April 13, 2021
Project No. 2312

**RE: Additional Information
Proposed Pine Meadow Road Solar Array "A"
BWC Pine Meadow Brook LLC
Off Pine Meadow Road, Northfield, Massachusetts**

INTERCONNECTION ALTERNATIVE #1

INTERCONNECTION ALTERNATIVE #2

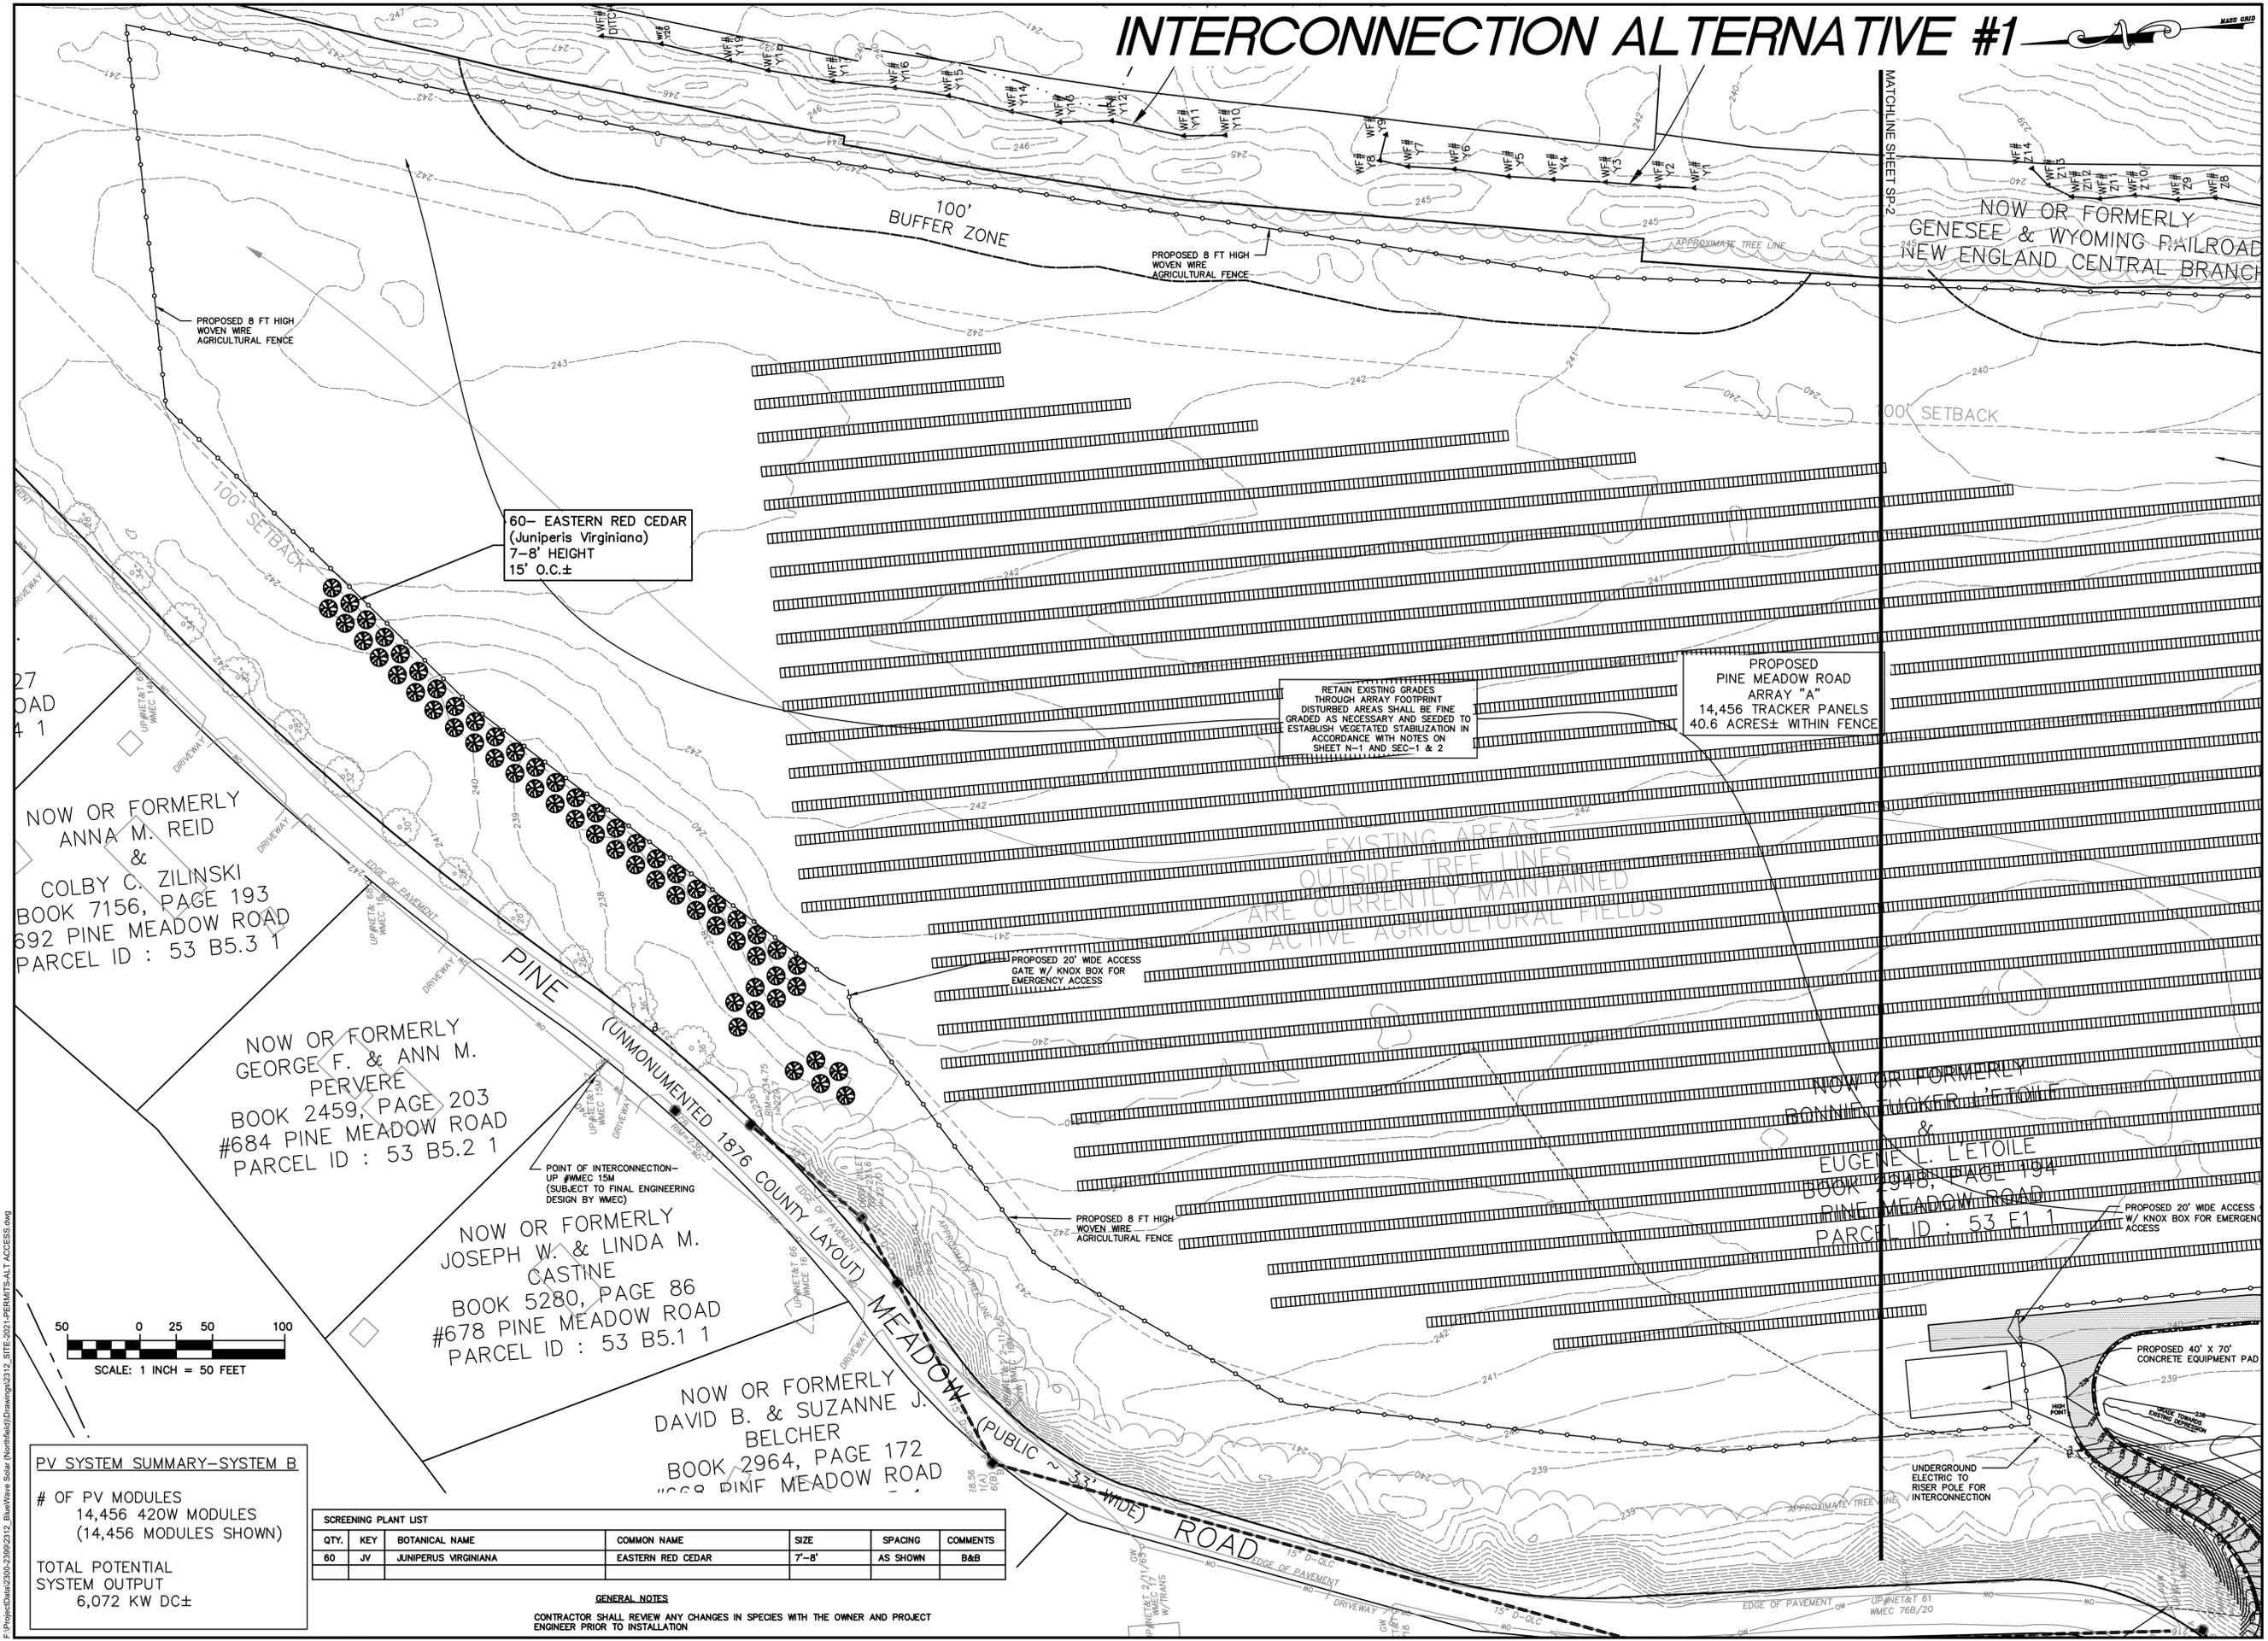
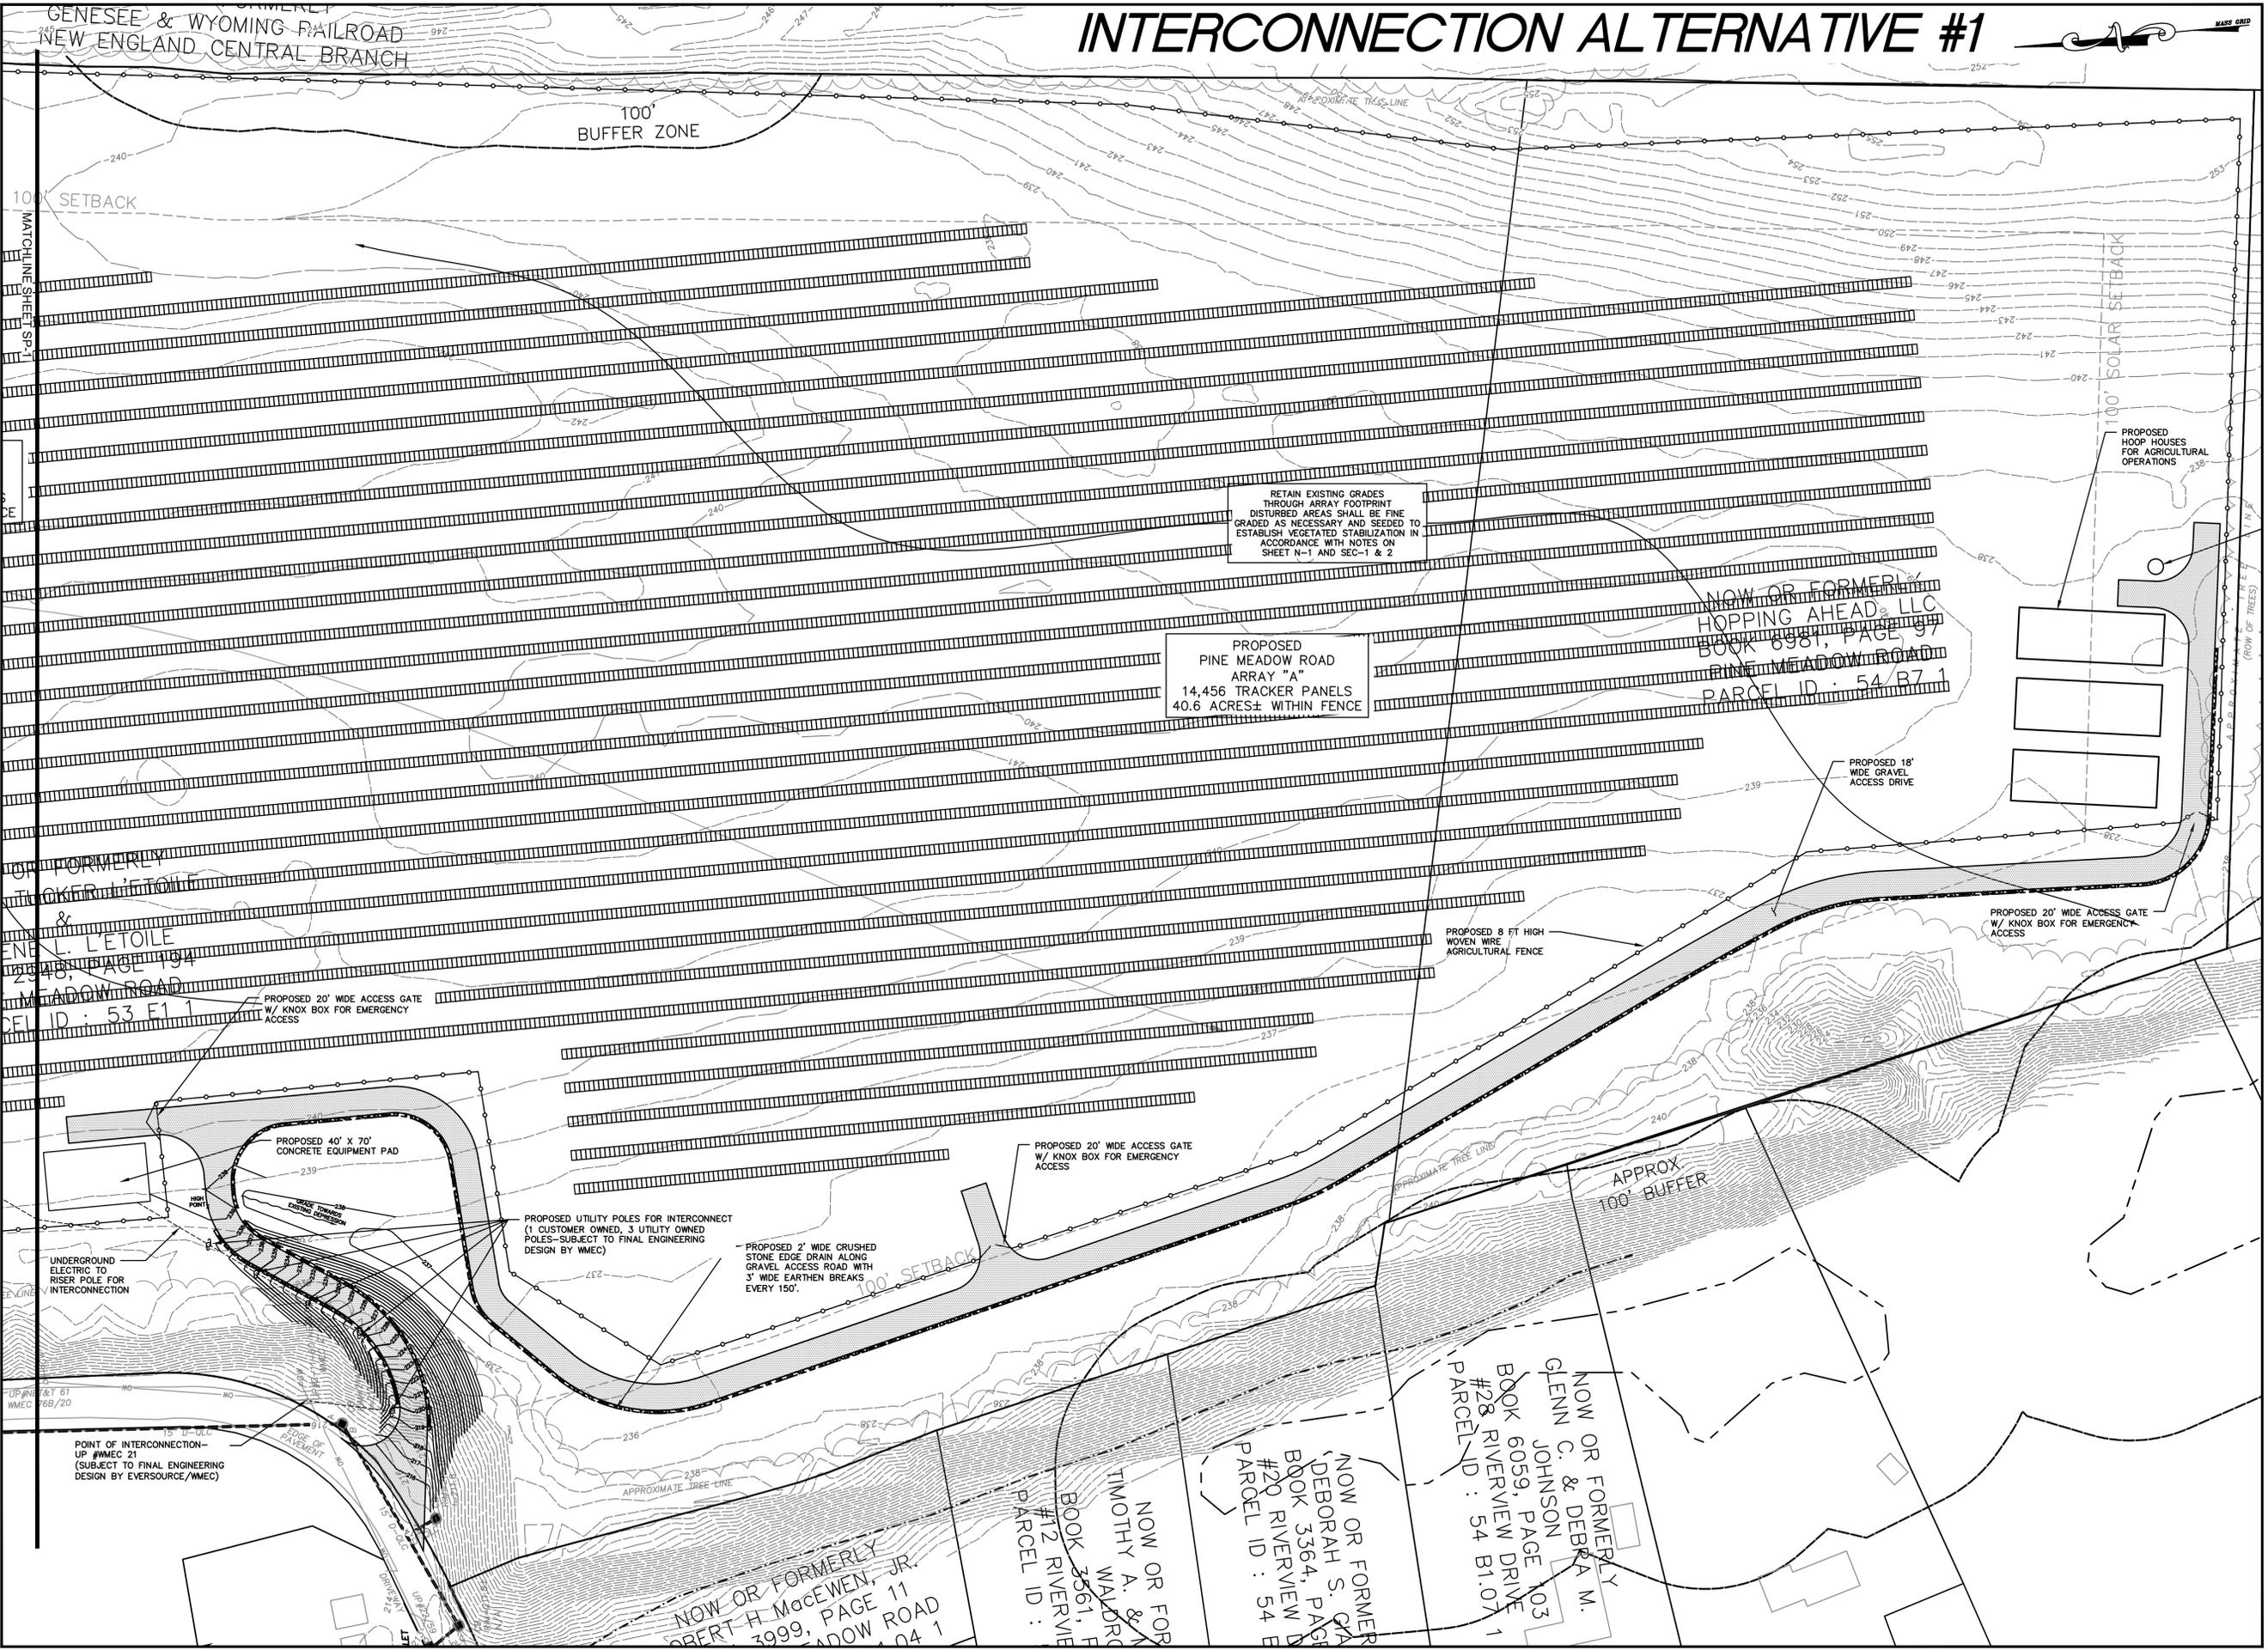
Alternative Interconnection Point 1 – Existing Pole #WMEC 21

The first alternative consists of connecting into an existing pole along the easterly side of Pine Meadow Road further south from the previously proposed point of interconnection. Pole #WMEC 21 is located along the S-curve portion of Pine Meadow Road further away from any existing residences than the previously proposed location. This alternative would allow the applicant to relocate the proposed access drive further south, away from the residences as well. The access driveway would be constructed through the existing berm as shown on the attached Site Plan at a maximum slope of 10%. The access driveway would be a minimum of 18' wide with a minimum 6' shoulder on the north side of the road to facilitate installation and access to the proposed utility poles associated with the interconnection. Construction of the access driveway will require less than 0.25 acres of tree clearing on the existing berm. Crushed stone trenches would be installed along each edge of the access driveway to collect stormwater runoff and reduce the potential for erosion towards Pine Meadow Road. FEC and BWC have reviewed a document entitled "Answers to Frequently Asked Questions about Gravel Roads" prepared by the Franklin Regional Council of Governments as provided to us by Eversource for specific details on the construction of the gravel access driveway and have followed the guidelines within that document where applicable.

Revisions			
No.	Description	Date	Appvd.
2	REVISED ACCESS ROUTE & INTERCONNECT DETAILS	4/12/21	RRR
1	REVISED PROPOSED INTERCONNECT DETAILS	2/23/21	RRR
